2027.00 Moss Lane East, Manchester

Design Co-ordination Amendments
New Building

Typical Upper Level Plan as Existing

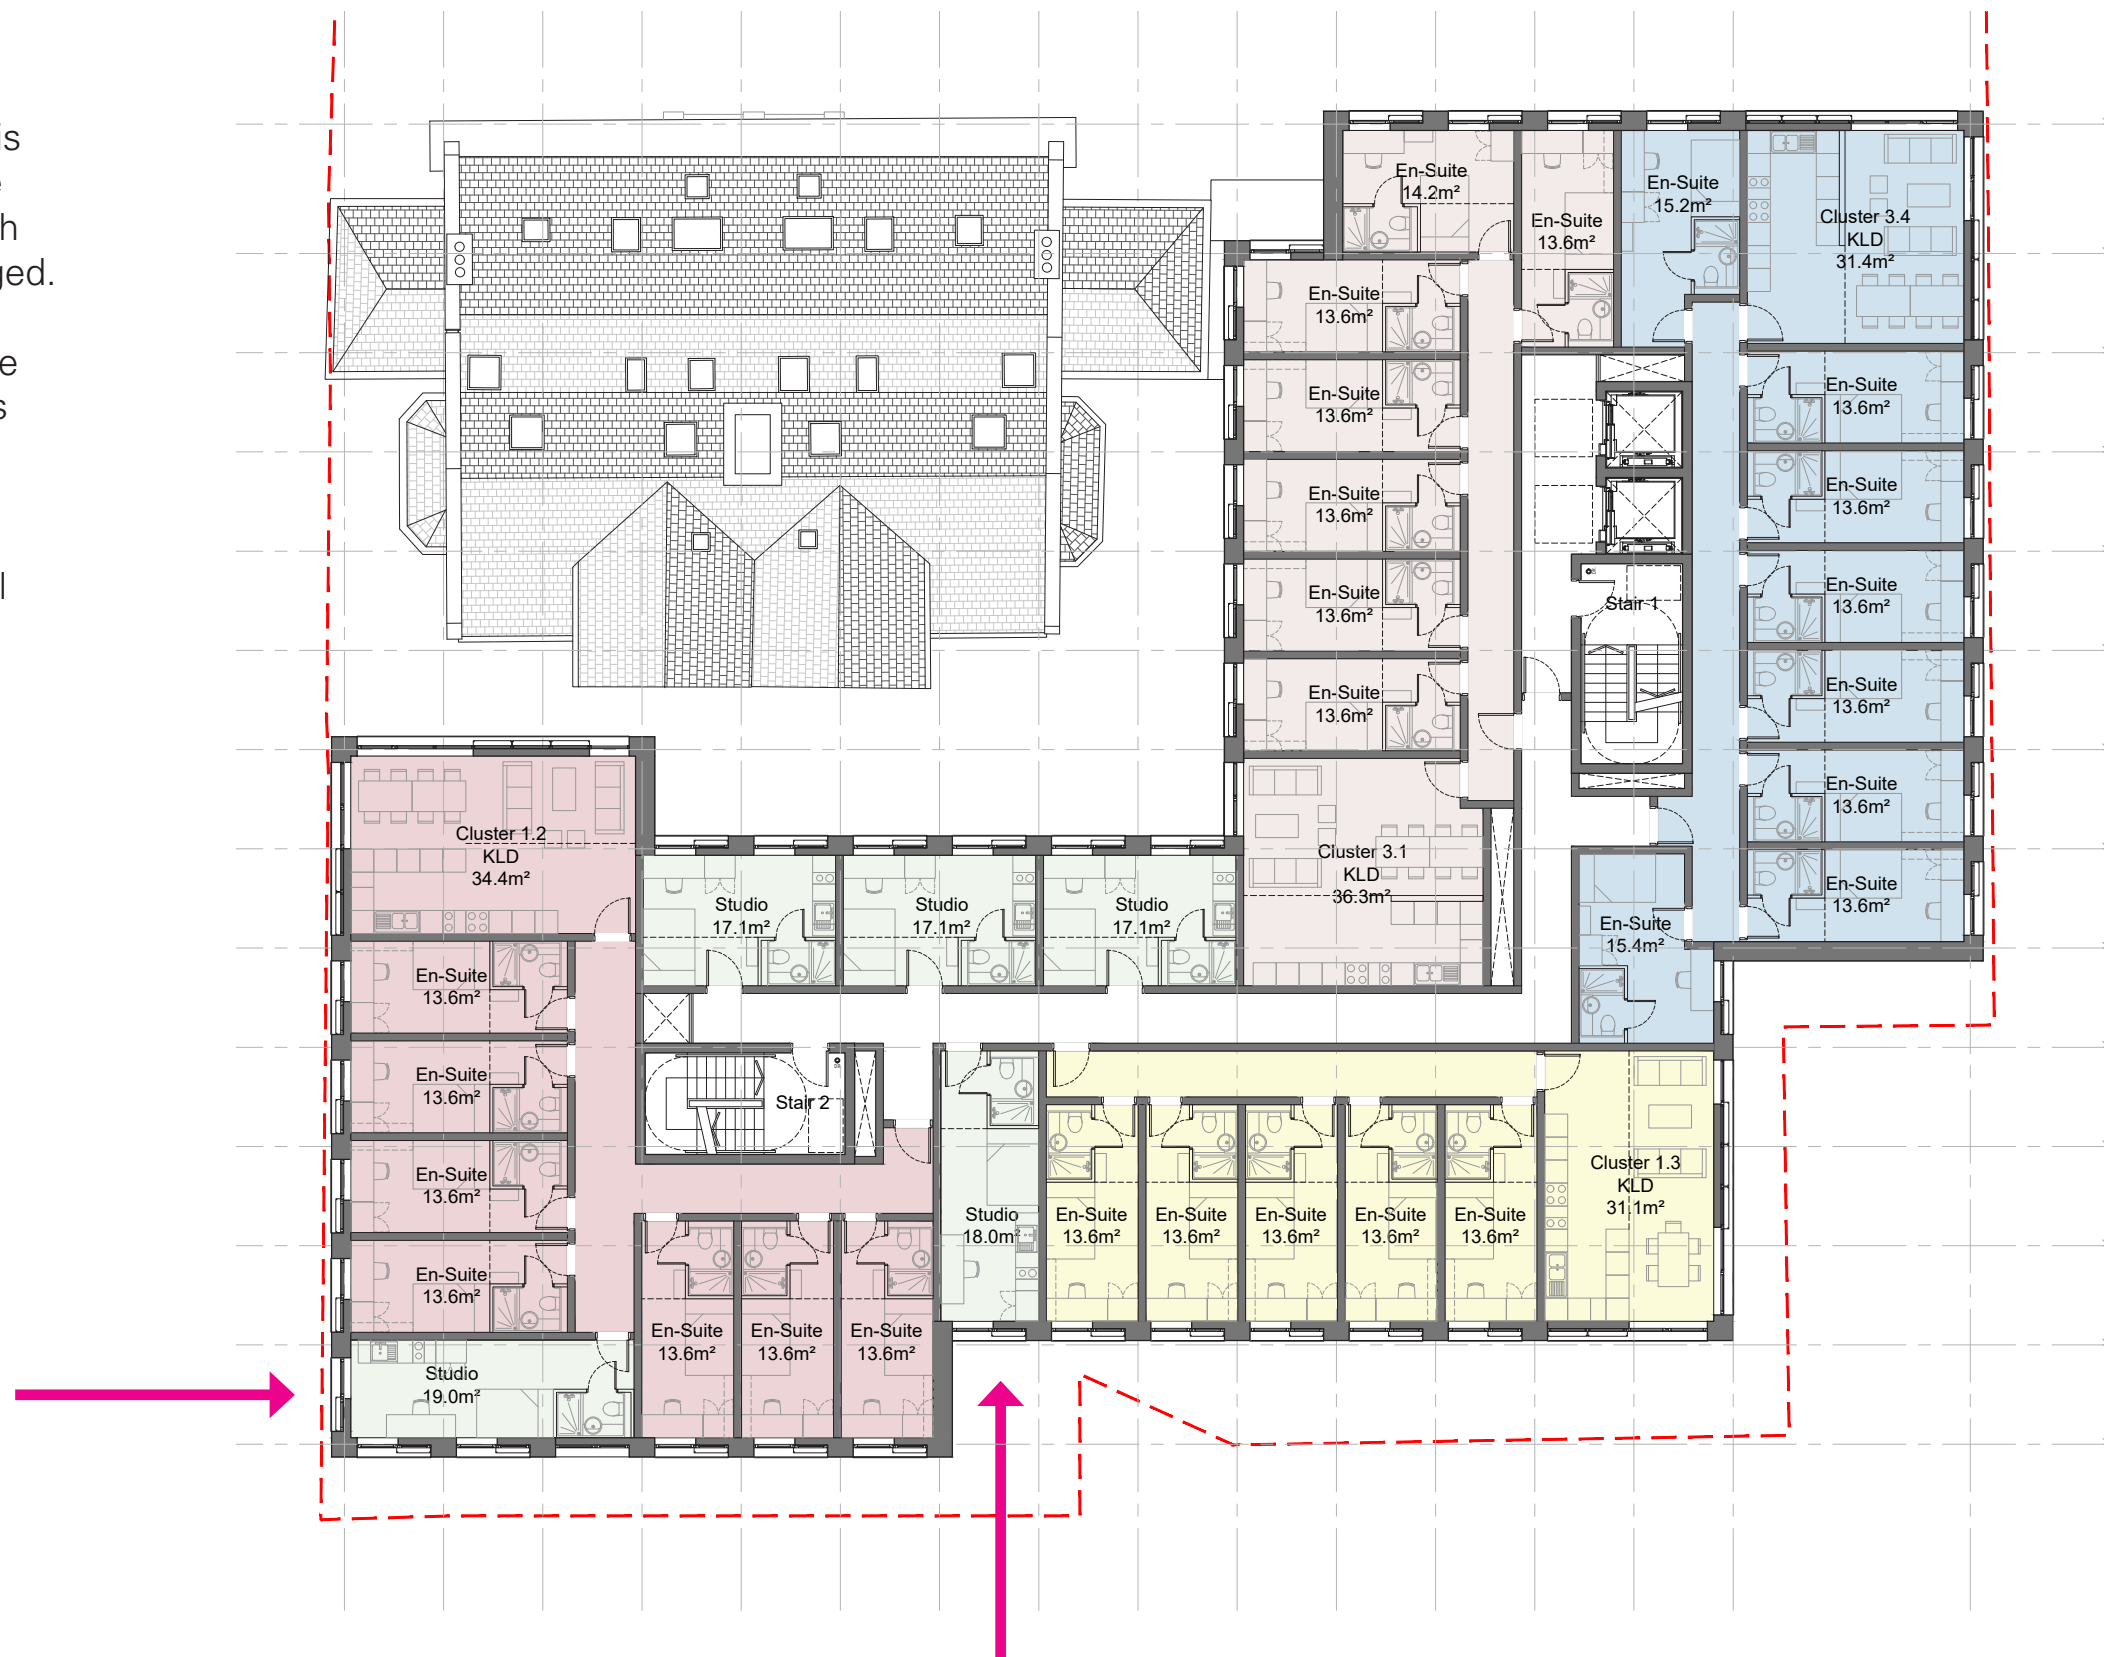
- In the new building, the consented accommodation mix includes 29no. cluster flats and 36no. self-contained studio units. The studios are arranged across the 9 storeys of the building.
- According to discussion with the operator, a slightly adjusted unit mix would be more in line with current demands within the student market. The currently proposed internal layout was examined with the view of increasing the number of self-contained studio flats.
- The adjacent floor plan shows the existing typical level plan layout.

- The minor adjustment to the accommodation mix is proposed by simply replacing some of the en-suite bedrooms in the cluster flats with studio units, with the overall number of units in the scheme unchanged.
- Two suitable locations for this were identified in the floor plan - one in each of the southern cluster flats - and the internal layout was revised accordingly to accommodate the swap-over.
- The adjacent floor plan shows the proposed typical level plan layout with the replacement studios adopted.

South Elevation as Existing

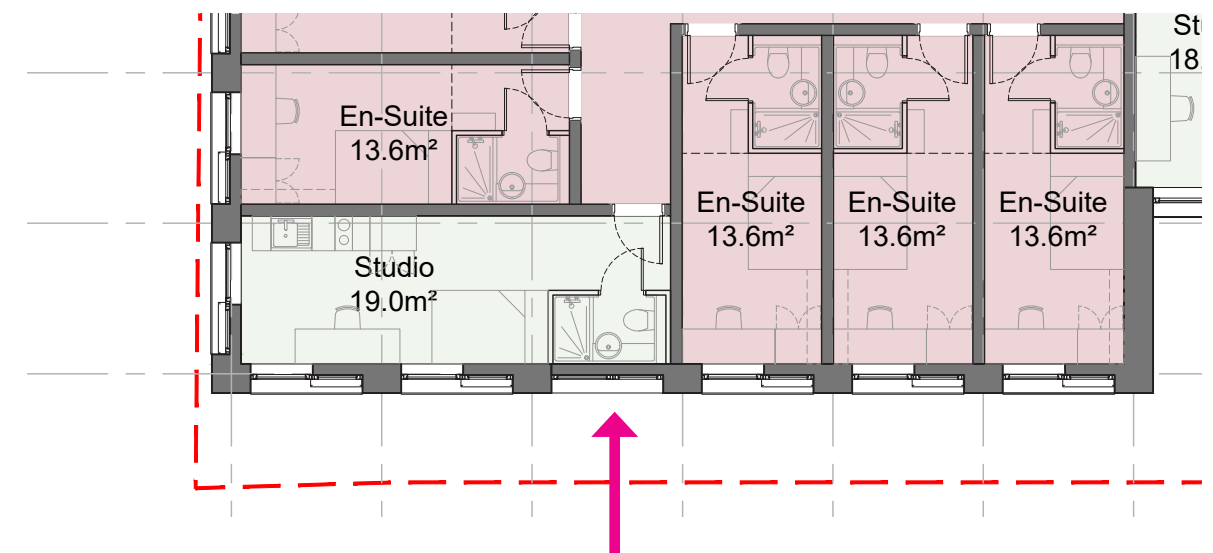
- With the introduction of studio flats where there would previously be en-suite bedrooms, implications of the proposed internal layout on the building elevations were also reviewed.
- The adjacent image shows the existing South Elevation (before the studio replacement).

- The wall space required for the proposed internal layout of the studio necessitates that one of its multiple windows is 'blanked off' where the bathroom pod is to be located.
- This adjustment is proposed by replacing the vision glass with a look-alike glazed spandrel panel, whilst the overall design of the window remains unchanged. The discreet nature of this ensures that there is minimal impact on the original aesthetics of the building facade.
- The adjacent images show the proposed South Elevation along with a part plan of the new studio in question.
- These corner studios still have three windows and dual aspect. The loss of one window is actually considered positive in that this creates more wall space and helps combat overheating given its south-facing location.
